6.3 Passive Core Cooling System

Figure 6.3-1
Passive Core Cooling System
Piping and Instrumentation Diagram (Sheet 1 of 3)

Figure 6.3-1
Passive Core Cooling System
Piping and Instrumentation Diagram (Sheet 2 of 3)

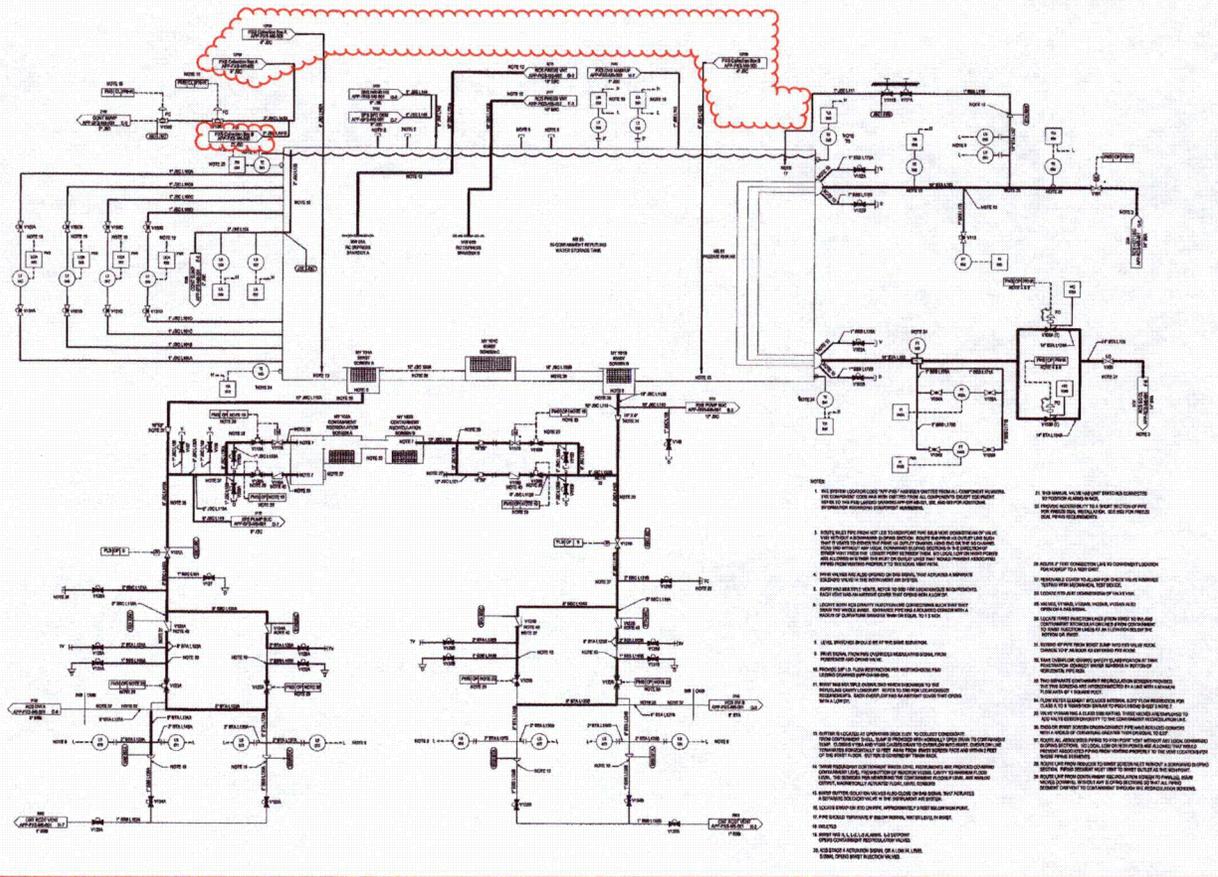
Figure 6.3-2 not used.

(Renumbered as Figure 6.3-1, Sheet 2)

Figure 19E.4.10-1

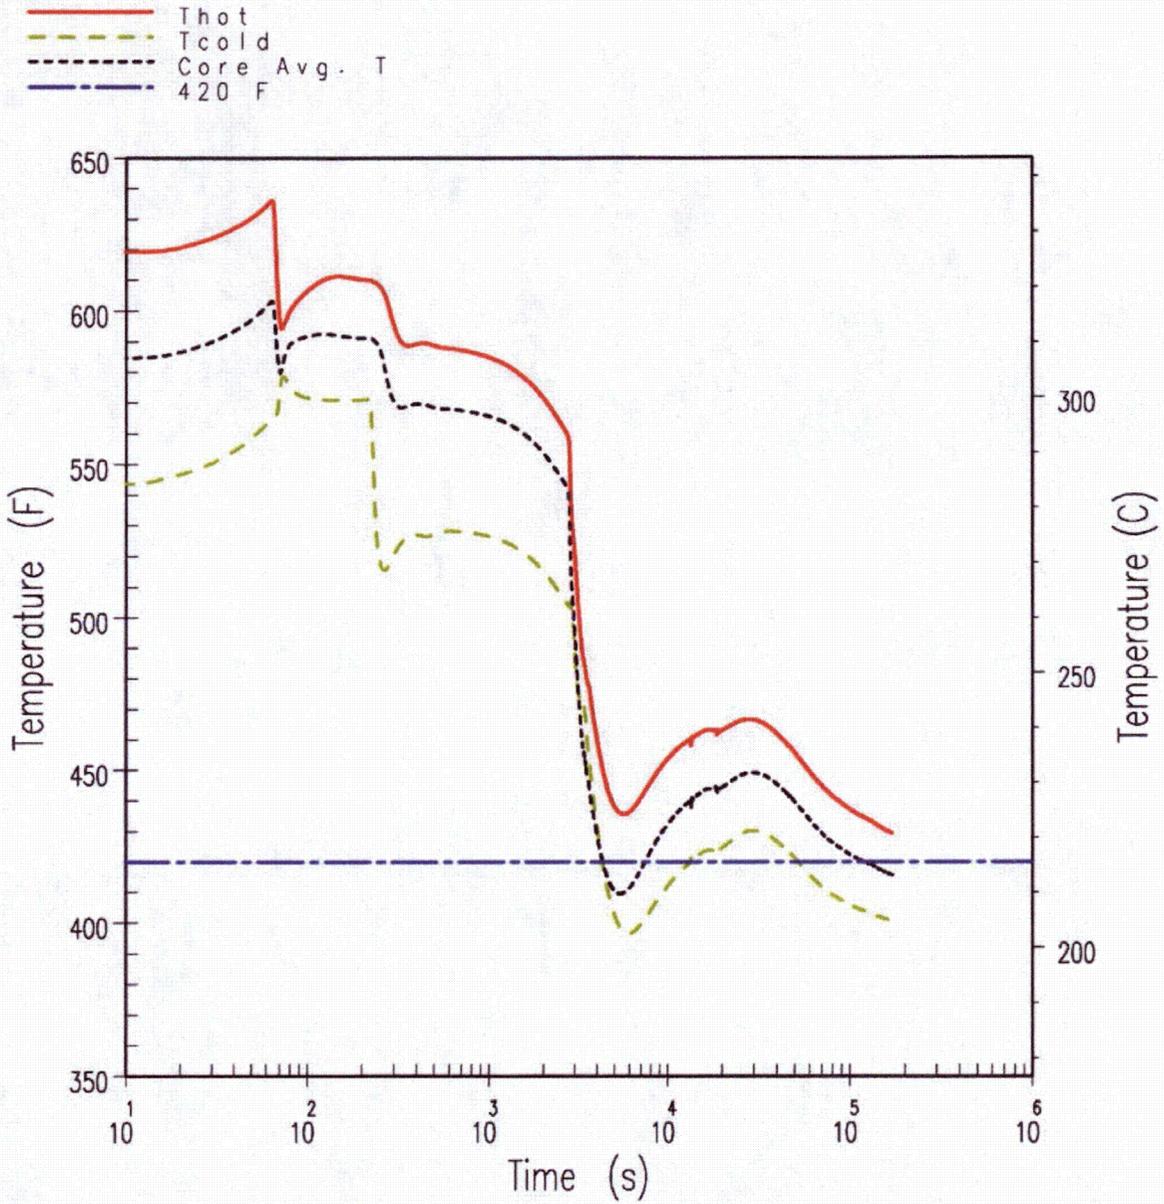
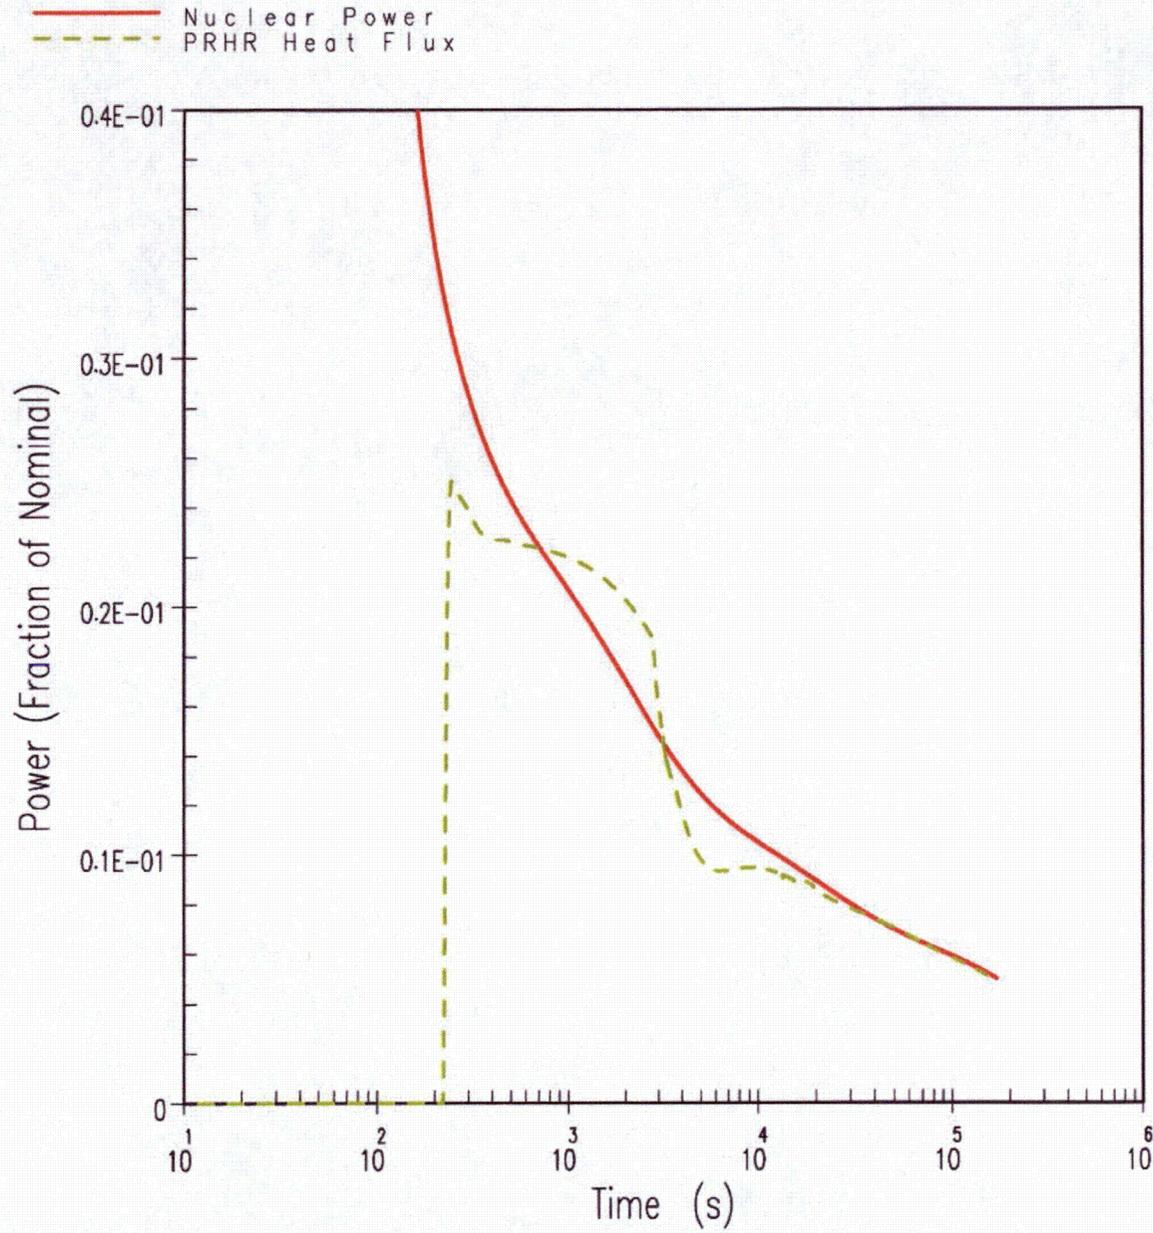
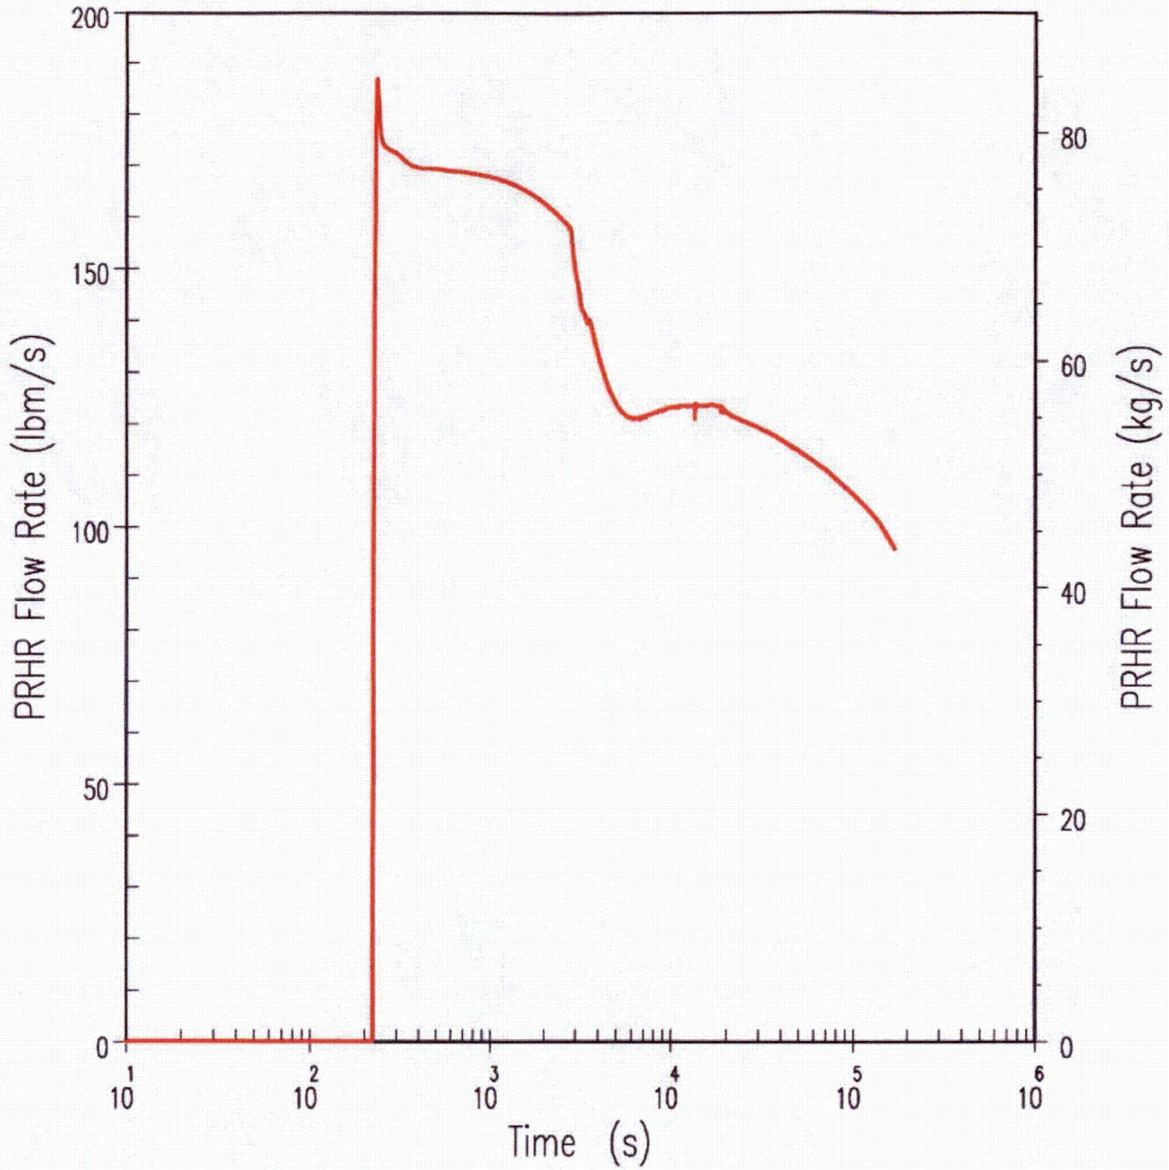
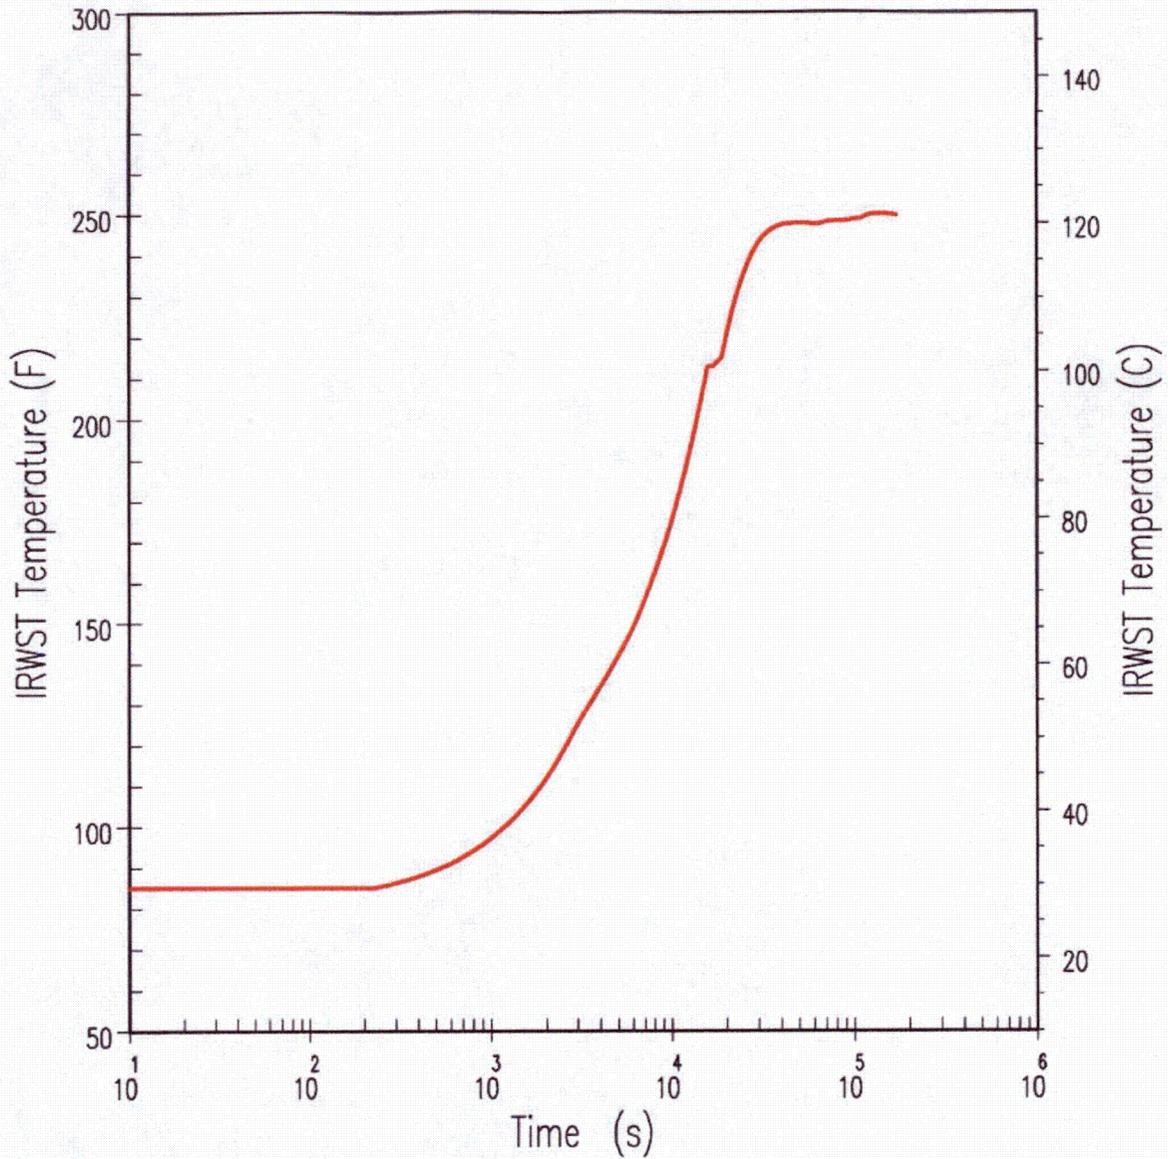
As discussed in subsections 6.3.3 and 7.4.1.1, the PRHR HX operates to reduce the RCS temperature to the safe shutdown condition following a non-LOCA event. An analysis of the loss of ~~main feedwater with a loss of~~ ac power event demonstrates that the passive systems can bring the plant to a stable safe condition following postulated transients. ~~The results of this A non-bounding, conservative analysis is are~~ represented in Figures 19E.4.10-1 through 19E.4.10-4. The progression of this event is outlined in Table 19E.4.10-1. ~~Though some of the assumptions of this evaluation are based on nominal conditions, many of the analysis assumptions are bounding.~~

Once actuated, at about ~~2,700600~~ seconds, the CMTs operate in recirculation mode, injecting cold borated water into the RCS. In the first part of their operation, due to the ~~injection of cold water flow rate~~, the CMTs operate in conjunction with the PRHR HX to reduce RCS temperature. Due to the primary system cooldown, the PRHR heat transfer capability drops below the decay heat and the RCS cooldown is essentially driven by the CMT cold injection flow. However, at about ~~6,0003,500~~ seconds, the CMT cooling effect decreases and the RCS starts heating up again (Figure 19.E.4.10-1). The RCS temperature increases until the PRHR HX can match decay heat. At about ~~46,70031,000~~ seconds, the PRHR heat transfer matches decay heat and it continues to operate to reduce the RCS temperature to below 420°F within 36 hours. As seen from Figure 19E.4.10-1, the cold leg temperature in the loop with the PRHR is reduced to 420°F at ~~about 82,600 in 52,900~~ seconds, while the core average temperature reaches 420°F ~~within at about 123,600 120,900~~ seconds (approximately 34 hours).
